Attention: Laura Friend (NRCB)
Jennifer Howe (IAAC / CEAA)

February 17, 2021

Re: SR1 Risk Comments

Hydrometric Stations:

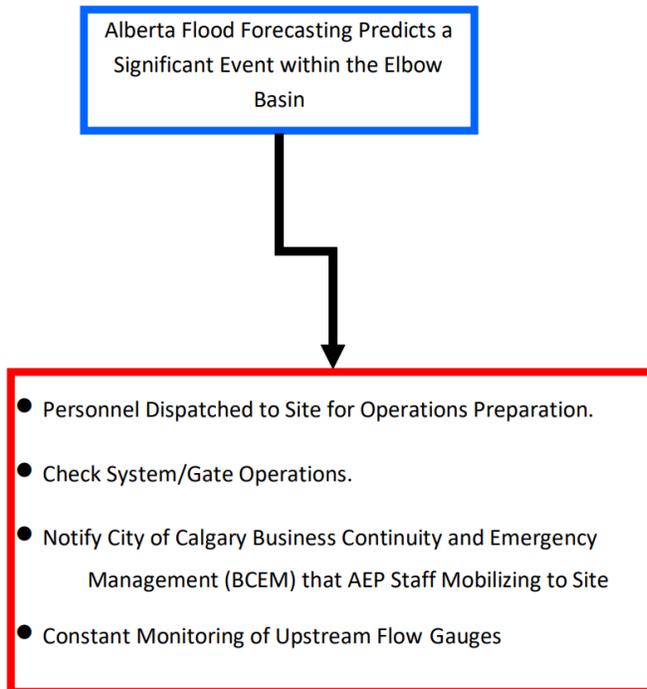
Is the assumption that hydrometric stations in operation DURING a flood event will be operational? The Proponent's statement uses the words "in operation prior to a flood season". What happens if the monitoring stations malfunction or do not properly read flood volumes as in 2013? What is the approach to diverting water? Visual cues? Based on what? This is a really big assumption and it would have been WRONG in 2013.

Decision to Divert

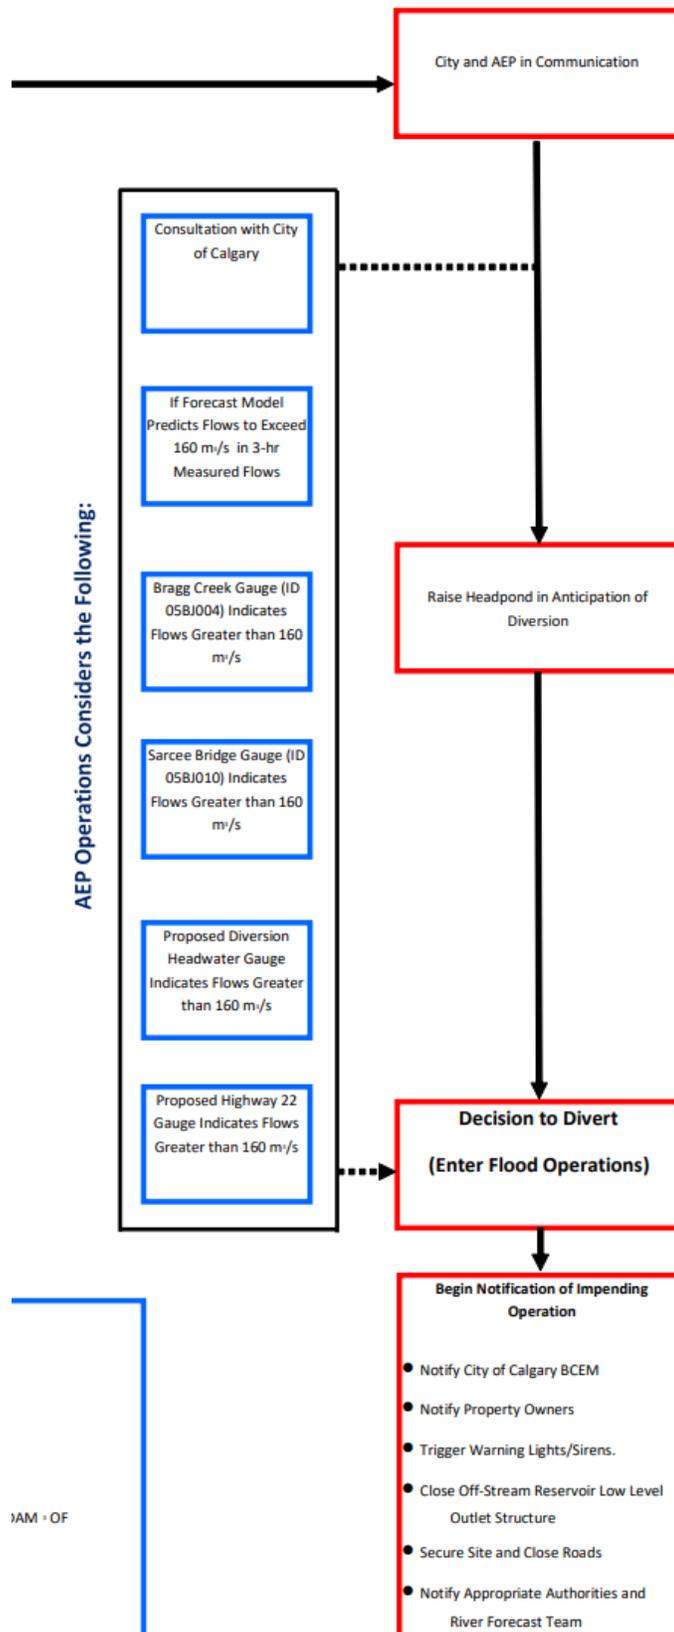
Comments:

- This is late for notification of residents in the area
- Also, closing roads will take time which is not considered

Questions:

- Do all stations need to read >160cms?
- What if one station is not reading? Does it matter which station?
- What if more than one station is not reading? Does it matter which stations?

- What if the station readings are contradictory? I.e. some are <160cms and some are greater?
- Is it possible that the Diversion gauge may not be accurate due to backwater behaviour or impacts of debris?

- Which gauge is the leading indicator of flood? Bragg Creek? Are there no stations upstream of Bragg Creek?
- In a river that is increasing in velocity, what is the variance that can exist between Sarcee Bridge and Bragg Creek? How is this accounted for and incorporated into the decision? For instance, is there a scenario where Sarcee is <160cms but Bragg Creek is more? How will this be reconciled and used in operations?

- Will the diversion be stopped if data readings are contradictory or suspected to be impaired?

Flood Operations

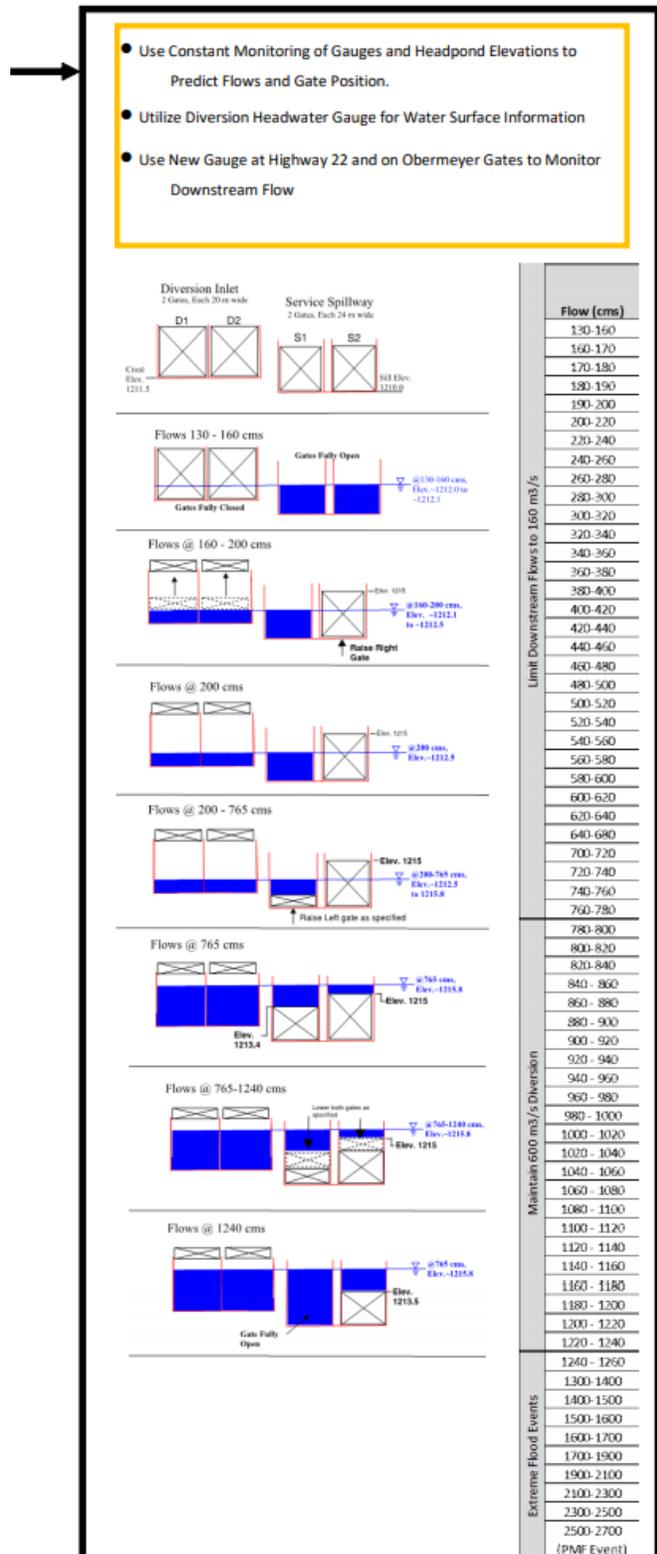
Comments:

- Operations over 1240cms are not identified.
- There is no reference to measuring the reservoir elevation here at all in order to assess if SR1 is approaching its full capacity. How will this elevation be measured and what level of confidence exists around this measurement?

Stop Diversion:

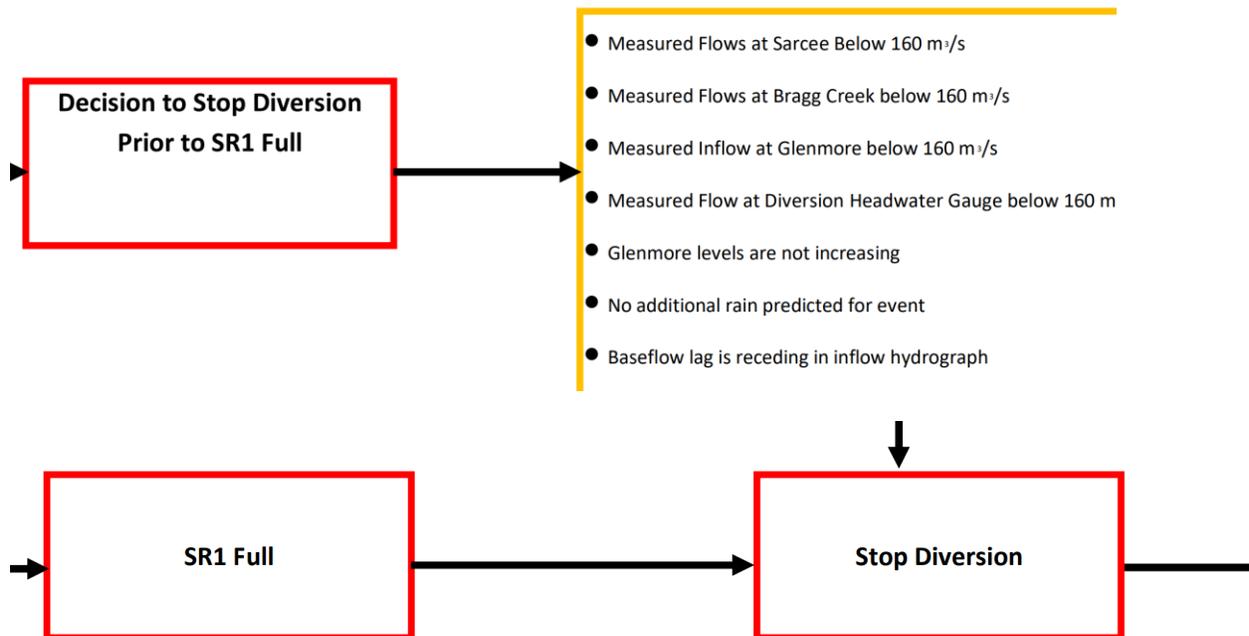
Comments:

- The SR1 “Full” box is glaringly empty.
- How is SR1 determined to be full and how is water in the diversion channel accounted for?
- Is someone monitoring the emergency spillway to see if it is activated as an indicator of full pool?
- There should be some warning or indicators for “SR1 Full” assessment, should there not? Will the water levels in SR1 be difficult to read if there is wind or unexpected behavior of the water in the reservoir (waves)?
- What is the impact of sediment deposition in the reservoir and its impact on elevations / volumes?

Alternate Operations Schemes

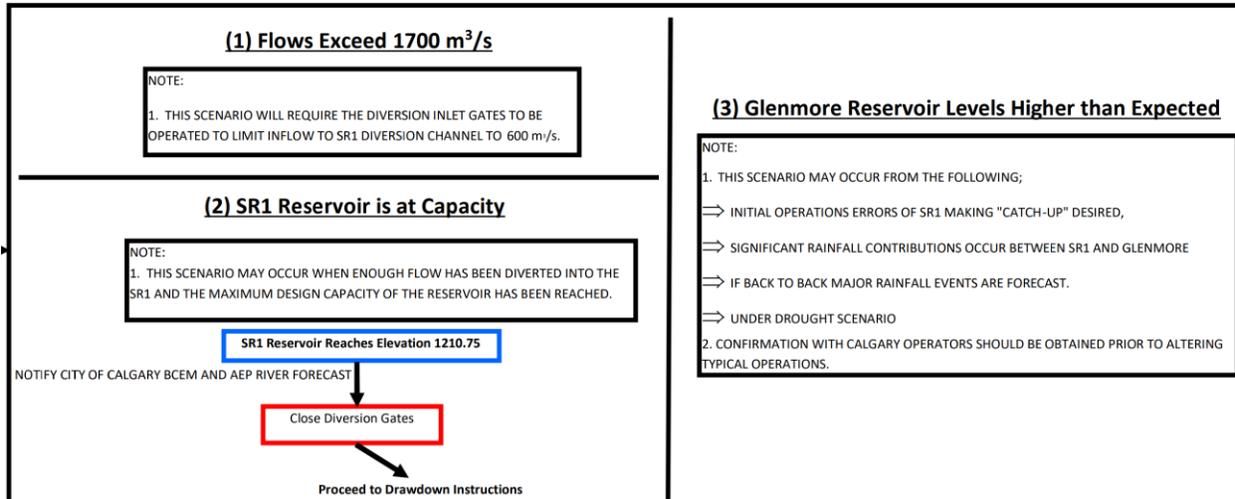
Comments:

- It is clear that the focus is protecting Glenmore “Confirmations with Calgary operators should be obtained prior to altering typical operations”. Is this the right protocol? Again, the main priority of SR1 operations should be to SAFELY operate SR1. That may sometimes contradict the best interests of Glenmore Reservoir operators and result in competing outcomes.
- We are concerned that the first fill(s) of SR1 will be full of uncertainty and operating risk. How will this elevation be established during a frantic diversion during a severe weather event? What is the margin of error here?

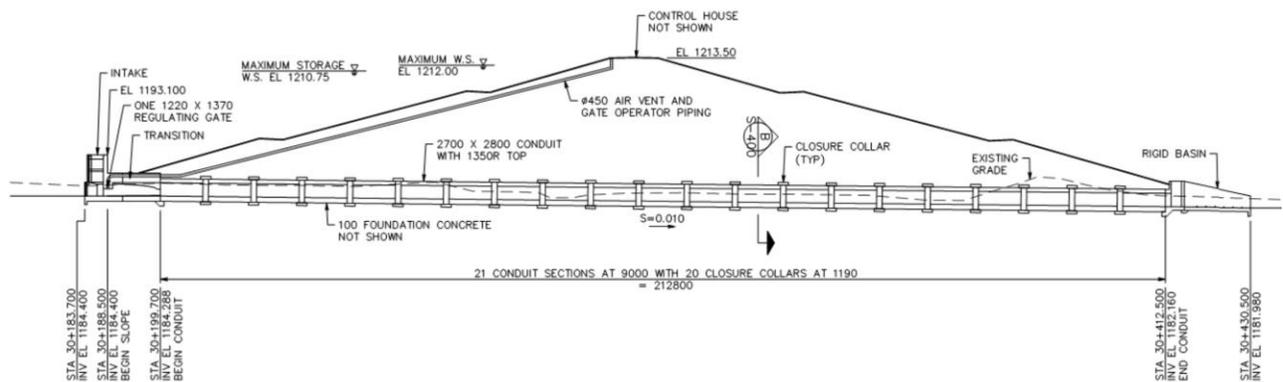
We ask Regulators to consider whether the entire emergency spillway should be riprap. What is the expected erosion of the emergency spillway during an event that requires it be activated at its full volume of 360cms? If the unnamed creek is riprap or erosion protected at flows <28cms, how is it possible that the emergency spillway has little to no erosion protection? For cost again?
